Recommendation to Mayor & City Council: Z-9444-2022

Z-9444-2022

- Rezone from C-2 (General Commercial) to MXD (Mixed Use)
- Includes New Sketch Plan
- Subject to the Requirements of the Lakeforest Mall Master Plan

Green Area:

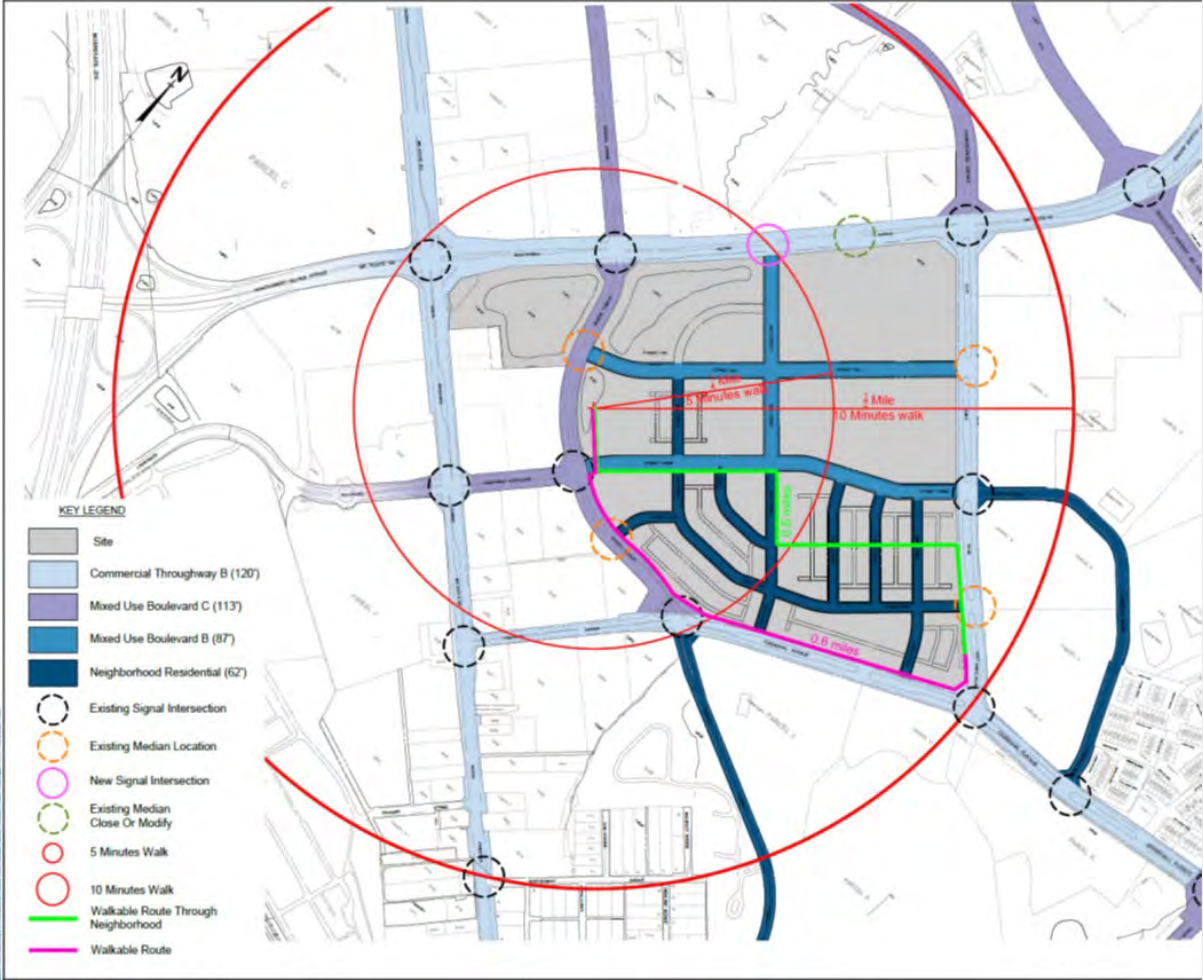
- Sense of Place
- Required Green Area
- Relocation of Transit Center
- SWM Pond 3
- Integration of civic uses for the greater area
- Preservation of the existing forested areas
- Daylighting the 84” storm drain pipe on the Lakeforest Site

- Reaffirms the Lakeforest Mall Master Plan Special Condition that establishes an overall minimum green area of 35%
